**B4453 Rugby Road Overbridge**

Schedule 17 Plans and Specifications

Written Statement for Information

HS2 Consents ID: WAC.PS.10053

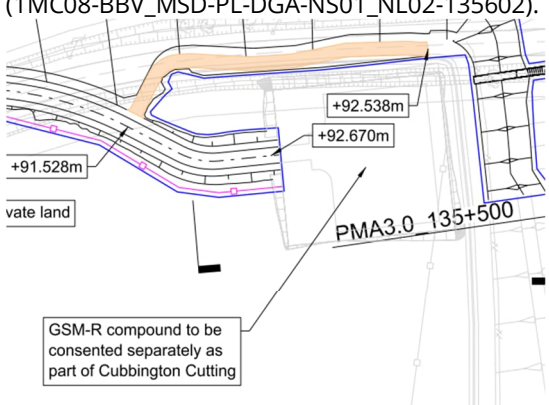
WDC/WCC/FC Comment	Applicant Response
<b>WDC comments</b>	
Boundary fencing appears to be shown immediately adjacent to the road. Existing conditions on Google Maps show Rugby Road to have grass verges either side, with hedgerows, and then boundary fences screened behind this. The proposals appear a bit back to front, and not in keeping with the surroundings. Could the location of the fencing be reviewed. It would also be a concern that the fencing	Boundary fencing has been updated following design development and is shown on the drawings within this pack.

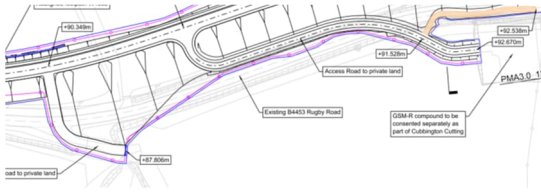
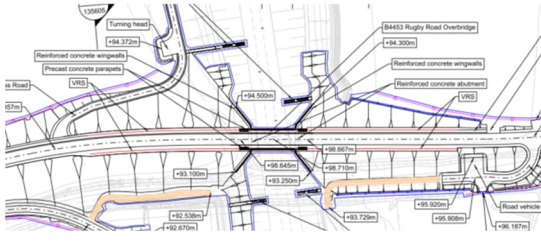
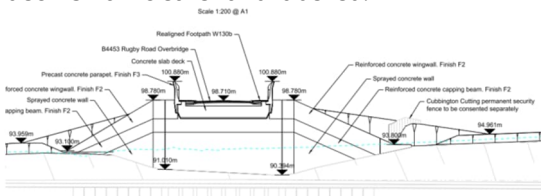
WDC/WCC/FC Comment	Applicant Response
<p>shown would not tie-in with existing fencing beyond the application boundary, can fencing be shown in grey outside of the site boundary to show it ties in. Fencing is also shown in front of the residential properties including across their access points, with no landscaping buffer.</p>	
<p>It would be useful to provide a section through Rugby Road in the suggested position to illustrate the boundary fencing, for clarity on the matter.</p> 	<p>See above response. An additional Section G (1MC08-BBV_MSD-PL-DSE-NS01_NL02-135606) has been added to the drawings.</p>
<p>Could this show existing with no solid fill within site boundary please so the existing Rugby Road arrangement can be seen.</p> 	<p>Drawing (1MC08-BBV_MSD-PL-DLO-NS01_NL02-135601) has been revised so that the existing Rugby Road arrangement can be seen.</p> 
<p>Greyed context appears to contradict proposals – no tie in / alignment and clash of MAS/drainage ditch. Labelling both MAS and drainage ditch to same thing. Does not correspond well with W/22/1770 consent.</p>	<p>The grey context has been removed from the GA drawing (1MC08-BBV_MSD-PL-DGA-NS01_NL02-135602) to avoid confusion, the disconnect in designs and poor tie in is due to B4453 Rugby Road Overbridge and Cubbington Cutting being at different design stages. Cubbington Cutting having already been accepted by the LPA, however the design has now evolved and any changes to the Cubbington Cutting design will be picked up by a future Schedule 17 consent.</p>

<p>Parking - please include justification within WS for use and size if not already, and label on plan. Spot heights missing from plan, and can you label some of the boundary fencing.</p> 	<p>This parking/turning area is to provide parking for vehicles within 200m of the overbridge to carry out inspection and maintenance as per the HS2 Access Technical Standard. The vehicles will be two long wheelbase vans or 4X4 all-terrain vehicles, at a frequency of once per year. The parking area has been designed to be the minimum size to accommodate the types of vehicles detailed above. Para 3.2.18 in the Written Statement now reads: "Vehicular parking is provided on both the eastern and western sides of the B4453 Rugby Road Overbridge crossing and the HS2 mainline. This parking serves as vehicle access to abutments for maintenance, the vehicles will be two long wheelbase vans or 4X4 all-terrain vehicles, at a frequency of once per year. The parking area has been designed to be the minimum size to accommodate the types of vehicles detailed."</p>

<p>Grey any context if labelling it otherwise confusing label of white space.</p> 	<p>The GA drawing (1MC08-BBV_MSD-PL-DGA-NS01_NL02-135602) has been updated to address the comment.</p>

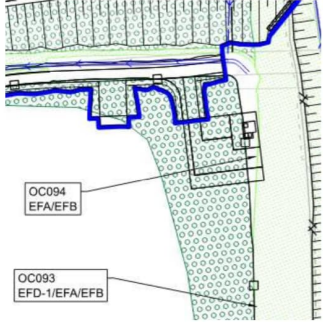
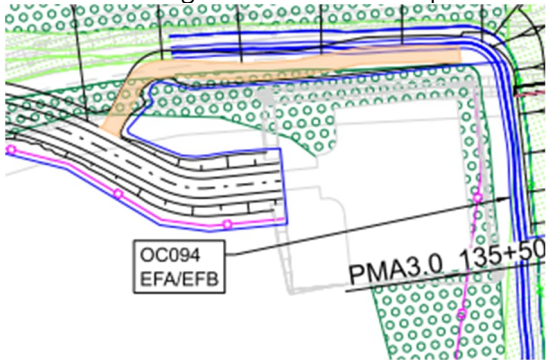
<p>Can context (or labelling) to these access points be shown in grey if there is any?</p> 	<p>The design has evolved at this location and the GA drawing (1MC08-BBV_MSD-PL-DGA-NS01_NL02-135602) has been updated.</p> 
<p>Clarification (and label) needed on what this is (left), also access to pumping station not clear.</p> 	<p>Labelling has been added to the GA drawing (1MC08-BBV_MSD-PL-DGA-NS01_NL02-135602) to address the comment.</p> <p>Note that the Rugby Road Pumping Station is no longer part of the asset following design development.</p> 
<p>Tie ins are poor, MAS running into earthworks and a drainage ditch. Not clear</p>	<p>The design has evolved in this location and the GA drawing (1MC08-BBV_MSD-PL-DGA-</p>

WDC/WCC/FC Comment	Applicant Response
	<p>NS01_NL02-135602) has been updated.</p> 
<p>Clear labelling required e.g., 'Rugby Road realigned'. Access road below need labelling.</p> 	<p>The GA drawing (1MC08-BBV_MSD-PL-DGA-NS01_NL02-135602) has been revised to address the comment.</p> 
<p>Safety barriers not shown on GA (yet drawn and labelled on Elevation A?) so need adding and labelling to plan if part of proposals. No mention anywhere in WS of safety barriers.</p>  <p>Road Pumping Station.</p>	<p>Due to design evolution, this comment is no longer applicable, as the highway, VRS and parking place are no longer proposed. The section of MAS now designed at this location does not include VRS on the GA drawing (1MC08-BBV_MSD-PL-DGA-NS01_NL02-135602).</p>  <p>GSM-R compound to be consented separately as part of Cubbington Cutting</p>
<p>Location of boundary fencing to be checked (across all drawing not just in above highlighted places) as it veers into MAS and crosses access points. Also shown hard against road, where existing boundary fencing is not, it is behind a grass</p>	<p>The design has evolved and the GA drawing (1MC08-BBV_MSD-PL-DGA-NS01_NL02-135602) has been revised to address the comment.</p>

WDC/WCC/FC Comment	Applicant Response
<p>verge. If tying back to existing boundary fencing this needs to be shown in grey outside of the site boundary to illustrate</p> 	
<p>Section C. Overbridge should be in 'distance' (greyed maybe) but should be visible. Appropriate to respond by way of written response on the type of section provided and that this would not show the bridge.</p>	<p>Sections provided are represented as a 'slice through' of the asset at that location and do not show objects that are distant from the location of the section line.</p>
<p>Where is drainage ditch, needs to be shown.</p> 	<p>Due to design evolution, this comment is no longer applicable, as a drainage ditch is no longer proposed at this location.</p>
<p>Wingwalls not clear on GA plan, can they be shown with lines and labelled.</p>	<p>The GA drawing (1MC08-BBV_MSD-PL-DGA-NS01_NL02-135602) has been revised to address the comment, wingwalls have been labelled.</p>

<p>Lines very unclear, section through deck needs clarification /tidying.</p> 	<p>The section drawing (1MC08-BBV_MSD-PL-DSE-NS01_NL02-135605) has been revised to address the comment, the section through the deck is now clearer and labelled.</p> 
<p>What are these?</p>	<p>The section drawing (1MC08-BBV_MSD-PL-DSE-</p>
